Selected aspects of the Danish repository program

Views from the outside – potentially (hopefully) helpful to improve the Danish discussion

Dialogue Meeting

Copenhagen, March 16, 2014

Theory: Deep disposal is much more expensive.

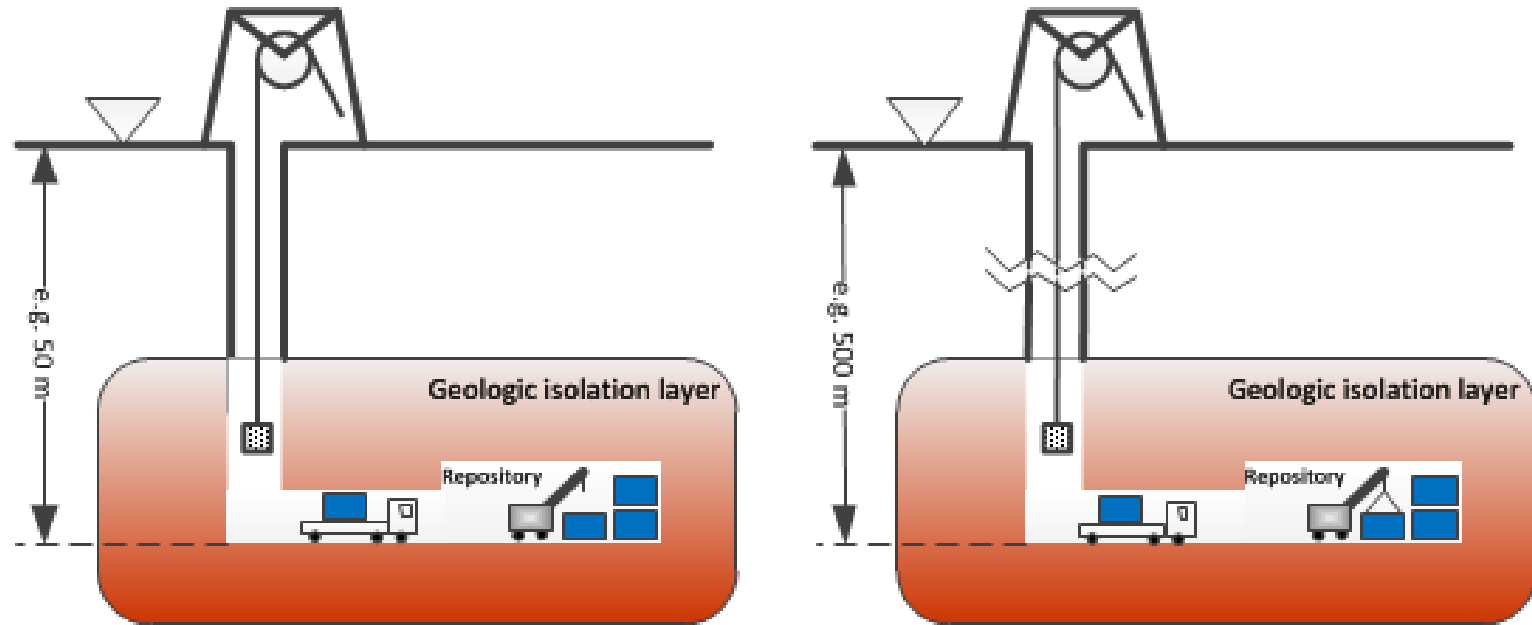
- In fact the economic difference between a shallow and a deep repository is in the worst case 450 m additional shaft drilling and 450 m of additional steel cable during shaft operation.

- All other much more relevant cost factors remain merely the same.
- It could as well be that shallow disposal is more expensive because of the less compacted geologic formation (requiring extensive lining of mine openings).

Aspect #2: Compliance demonstration

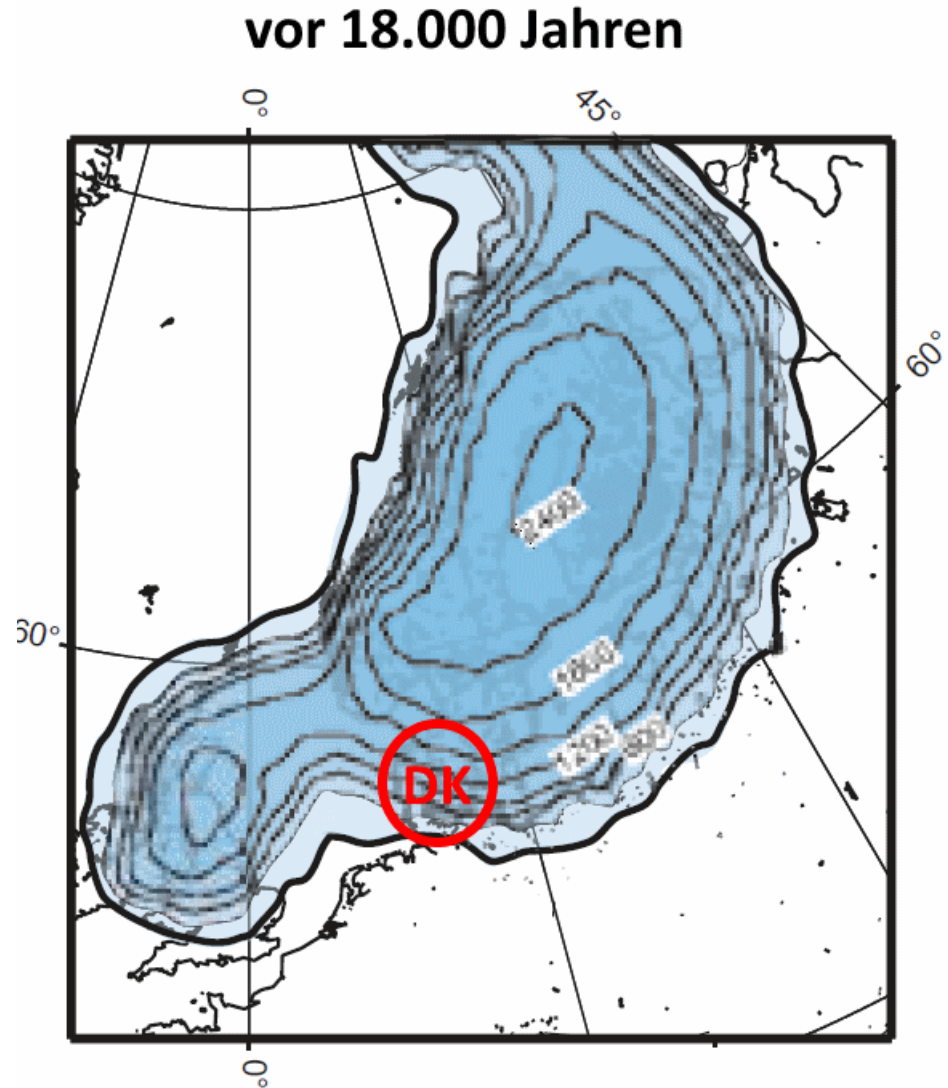
- The integrity of the disposal cell resp. repository has to be guaranteed over very long times.
- For surface-near locations down to 100 m below ground, the integrity proof cannot be demonstrated.
- It is only possible to evaluate long-term safety and regulatory compliance in a reliably functioning isolation system.

Is the spent research fuel the problem?

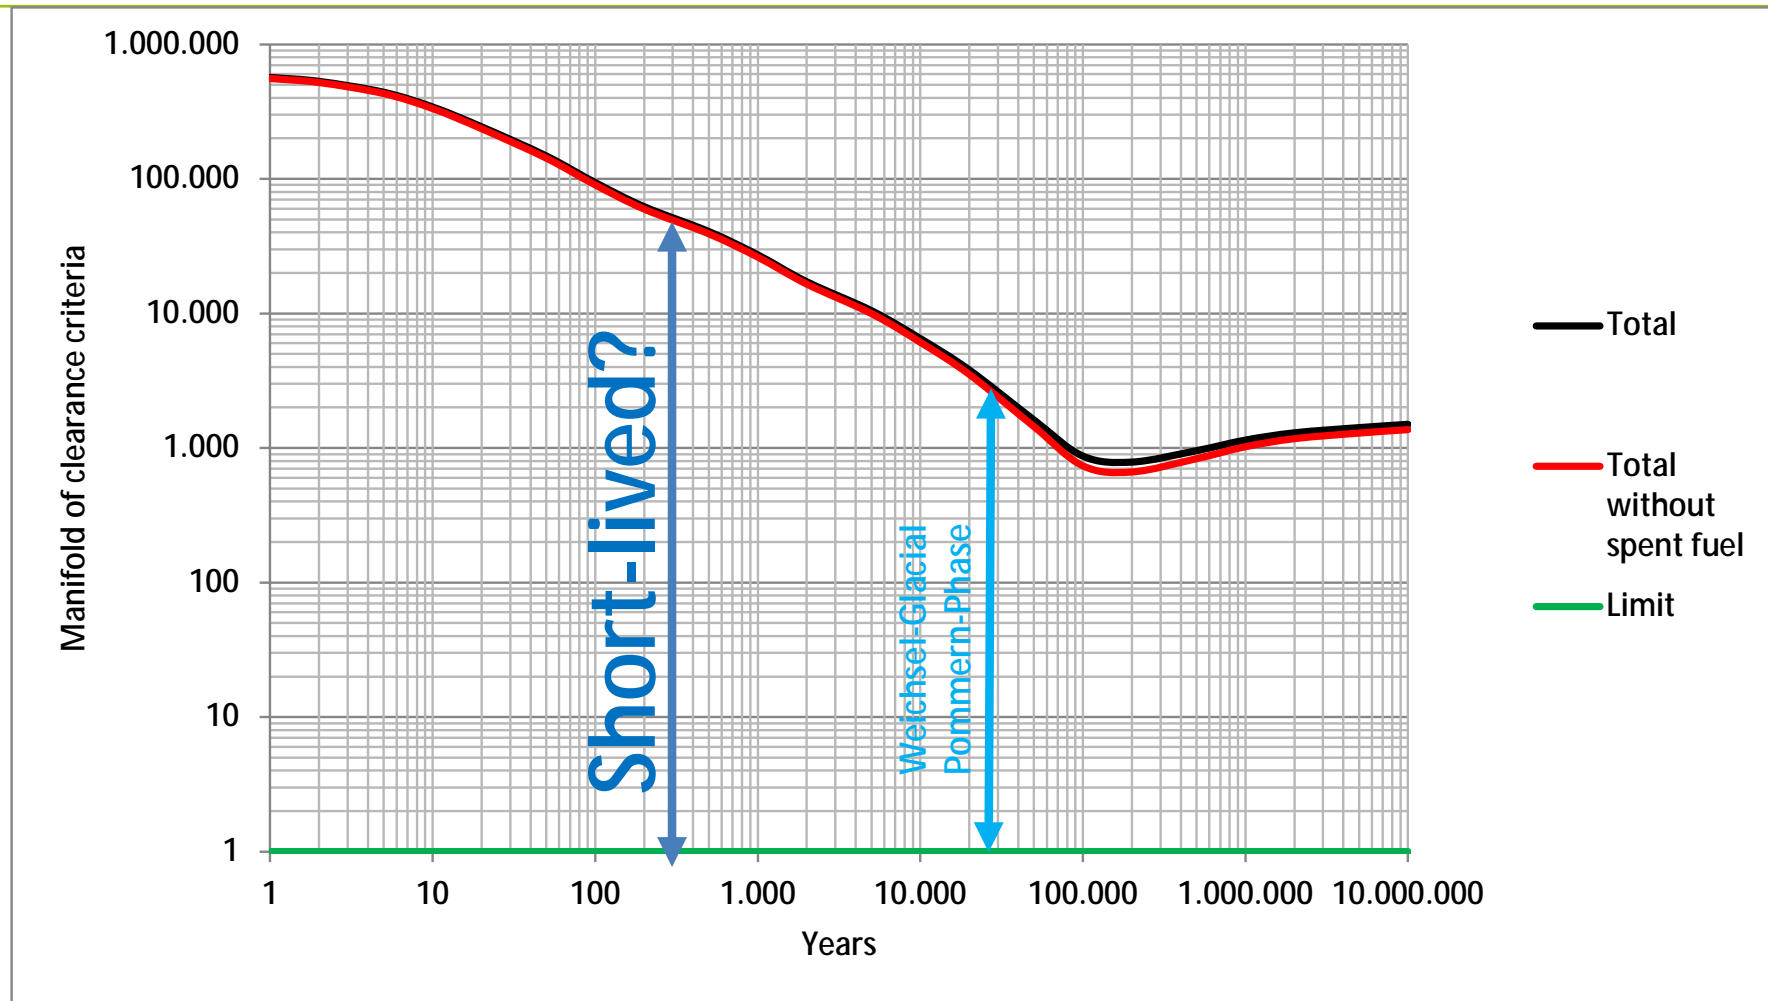
- The difference of the Danish inventory with or without the spent fuel is hardly to be seen in the diagram. Removal of the spent fuel and an extra-option for the spent fuel does not change the isolation requirements to a relevant extend.

2007 recommendations (2)

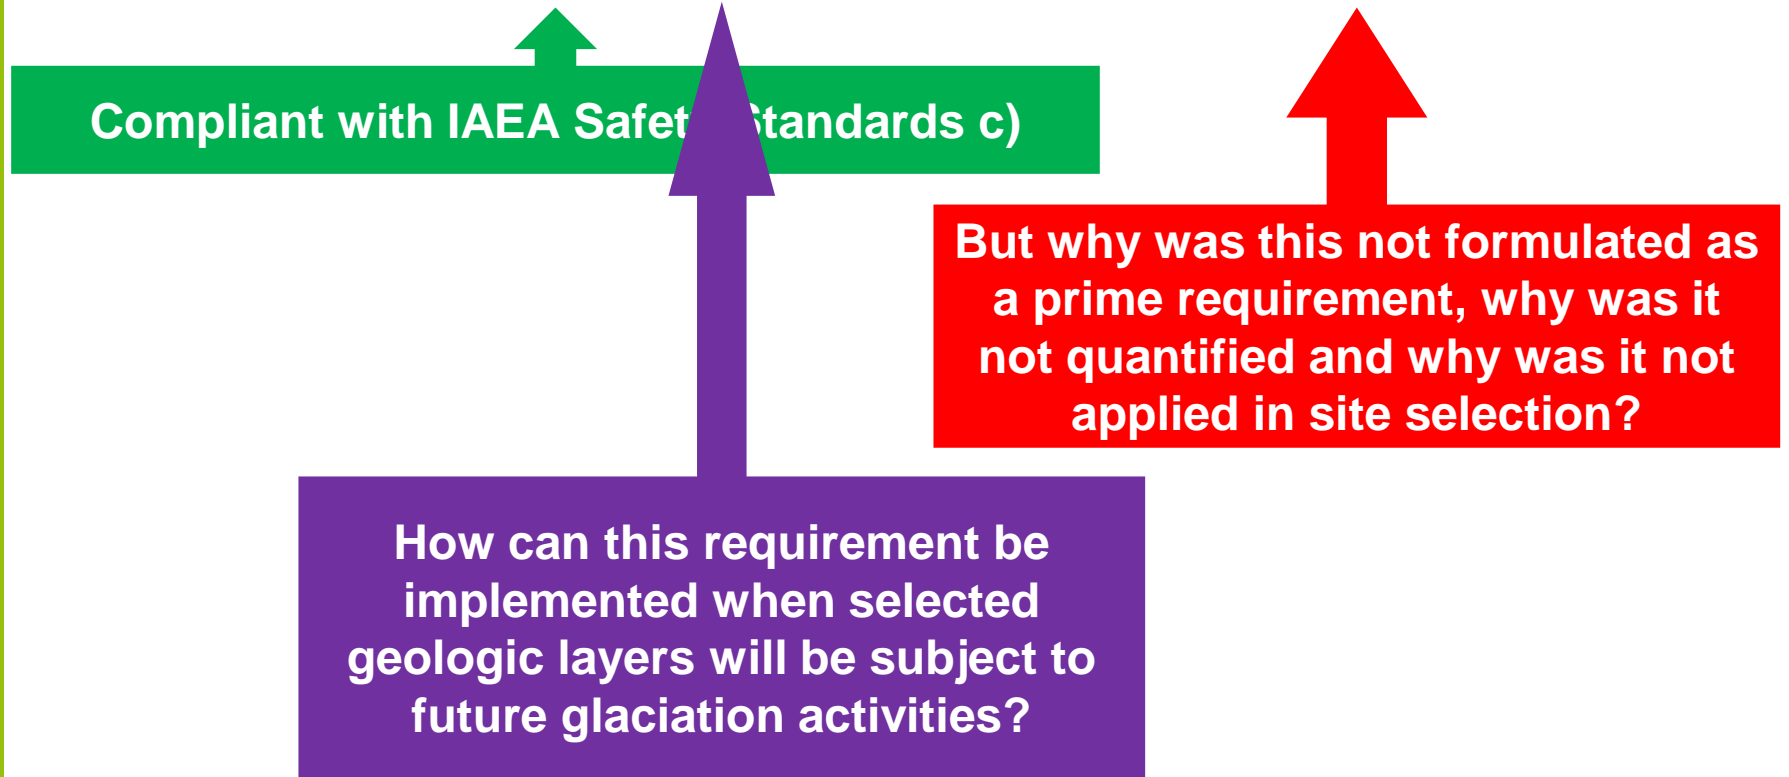
But why was this not formulated as a prime requirement, why was it not quantified and why was it not applied in site selection?

How can this requirement be implemented when selected geologic layers will be subject to future glaciation activities?
